15 February 2012

**ENVIRONMENTAL ASSESSMENT – DEXUS ESTATE INDUSTRIAL PARK PROJECT (MP 08_0259)
MODIFICATION (MOD 3) – SUPERLOT A AMENDMENT**

Figure 3: DEXUS Estate Masterplan – As Proposed (MOD 3)

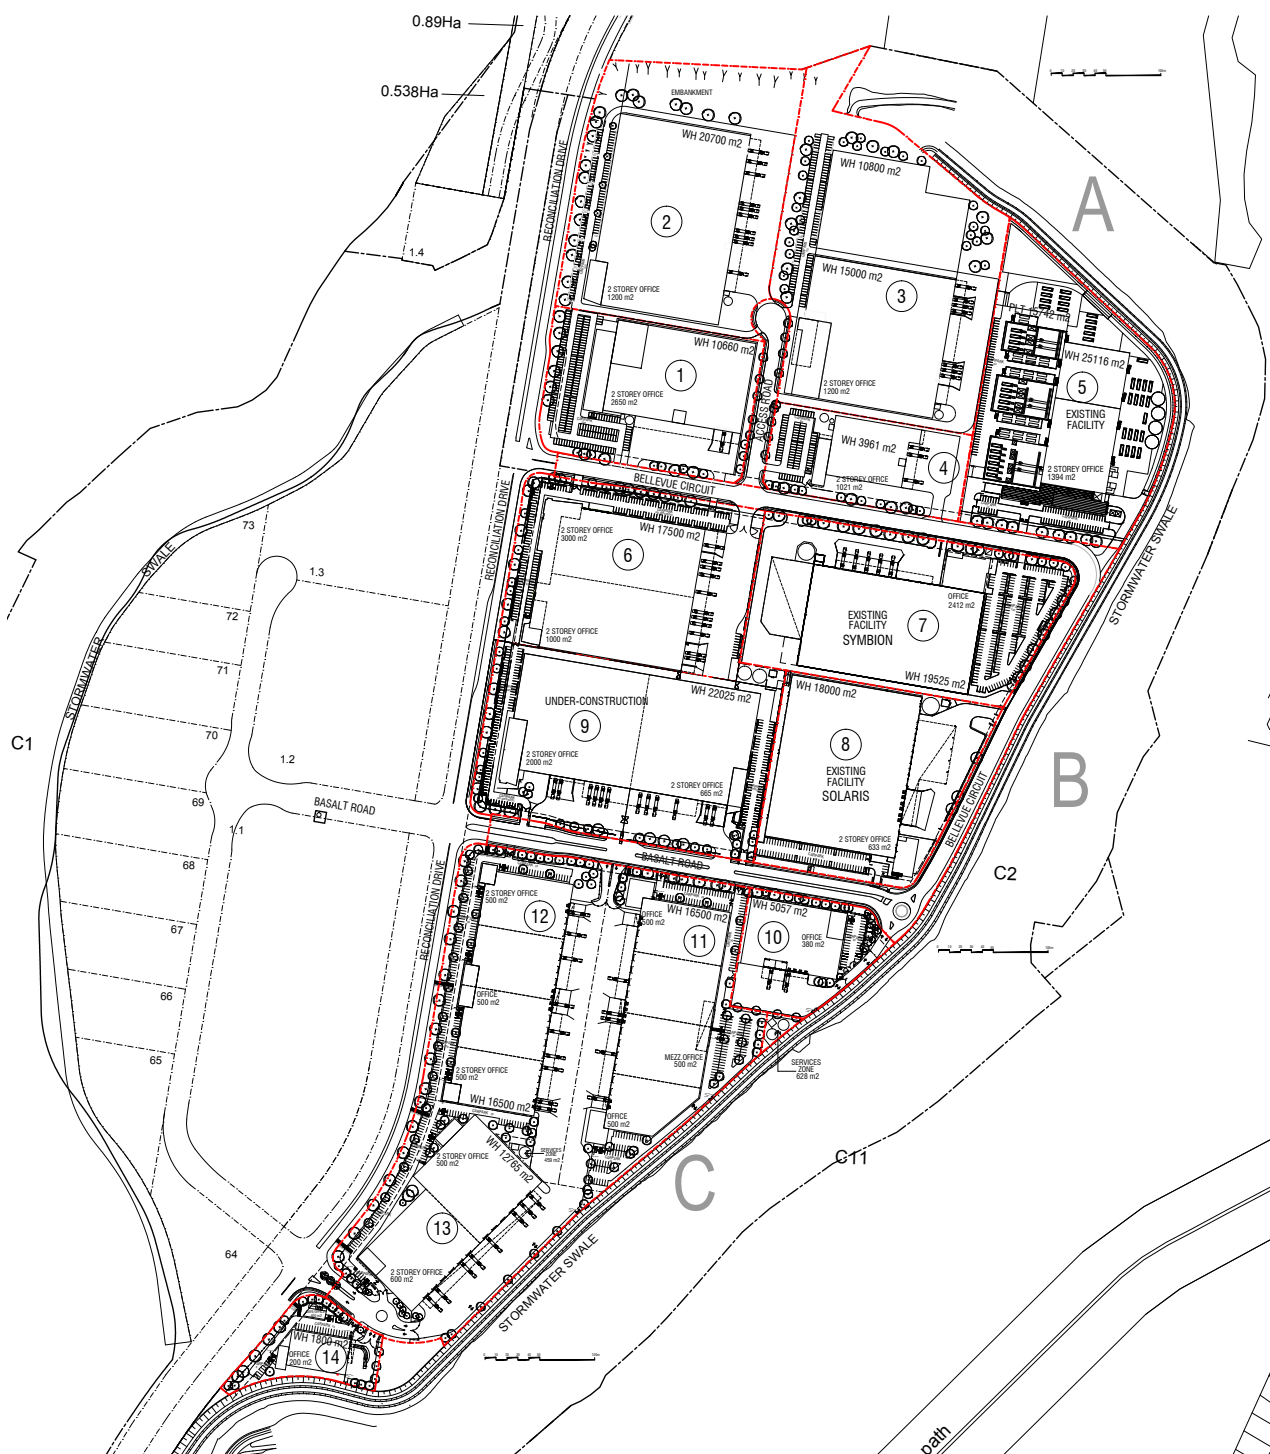
- amend the DEXUS Estate masterplan layout for Superlot A, including:
 - subdividing the 2 residual development lots into 4 development lots, and an estate road lot;
 - amending the masterplan building layout to reflect the proposed Brady and Voith Turbo Facilities and the revised lot layout, including the additional estate access road; and
- allow the industrial/manufacturing use of the proposed Brady and Voith Turbo Facilities.

The proposed revised masterplan for the DEXUS Estate is shown on **Figure 3**. The Brady and Voith Turbo Facilities would be constructed on Lot 1 and Lot 4, respectively¹. A full set of revised architectural design plans – based on the proposed masterplan – is attached as **Appendix A**. A revised Landscape Masterplan for the estate is attached as **Appendix B**.

It is noted that, to enable the access road to be constructed strictly in accordance with AS 2890, the heavy vehicle driveway into the approved Warehouse B Facility has been amended slightly to form a 4-way intersection at this point. The intersection is shown on the proposed masterplan layout (see **Figure 3**). DEXUS would amend the approved Warehouse B Facility plans to reflect this minor change prior to construction of the facility.

Figure 4: Proposed Brady Facility (Lot 1)

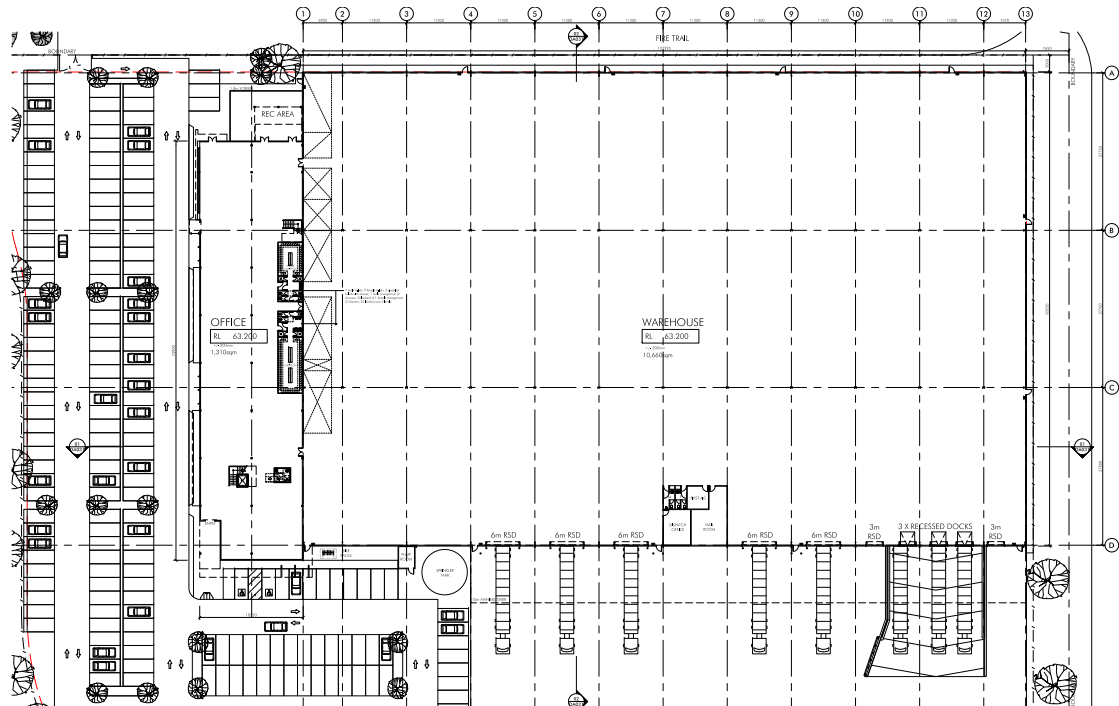
The proposed Brady Facility (on Lot 1) would be used mainly for warehousing and distribution of imported product, however the facility would also involve some product assembly, digital printing, label conversion and screen printing. The layout of the proposed facility is shown on **Figure 4**. The production area would comprise approximately 1,116m² of the total warehouse area of 10,660m².

Figure 5: Proposed Voith Turbo Facility (Lot 4)

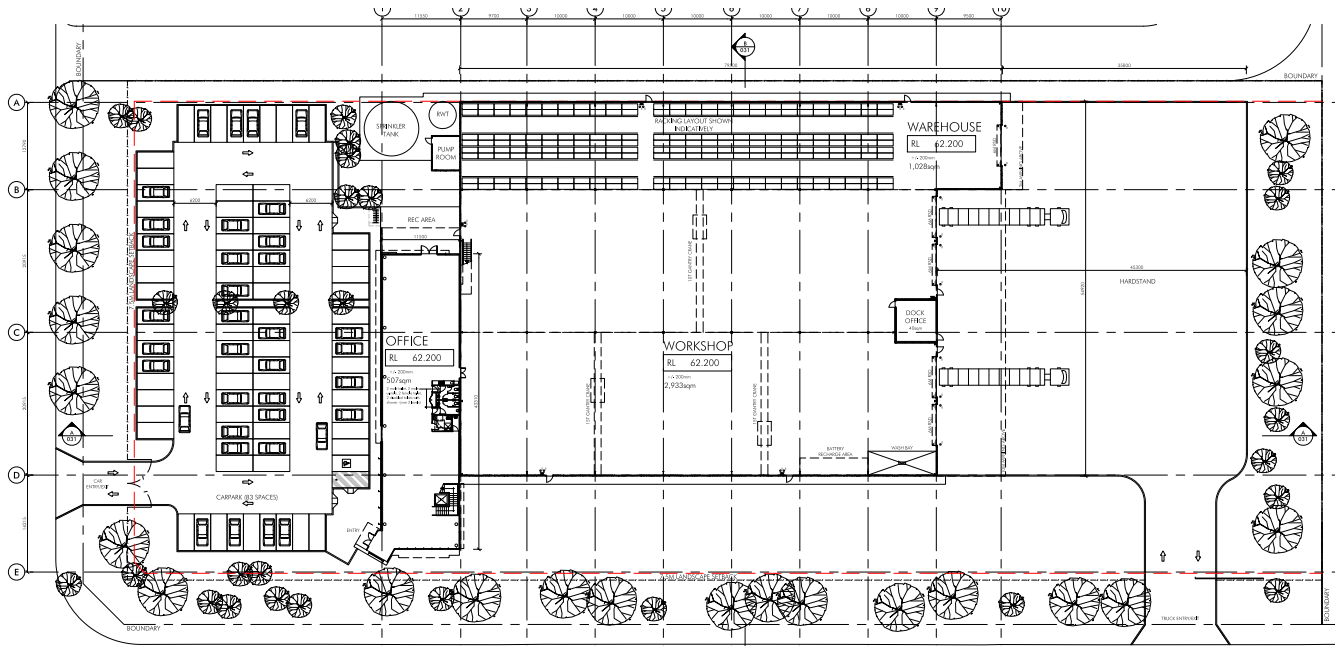
The proposed Voith Turbo Facility (on Lot 4) would be used for warehousing and distribution of machinery parts, as well as dis-assembly, assembly, repair and spray painting of drive systems (eg. railcar couplings) and other components. The layout of the proposed facility, showing the proposed workshop area, is shown on **Figure 5**. The workshop area comprises approximately 2,933m² and the warehouse comprises an area of 1,028m². It is noted that the masterplan layout and the development schedules presented in Tables 2 and 3 above include an allowance for an additional future expansion of the warehouse/workshop of some 1,130m².
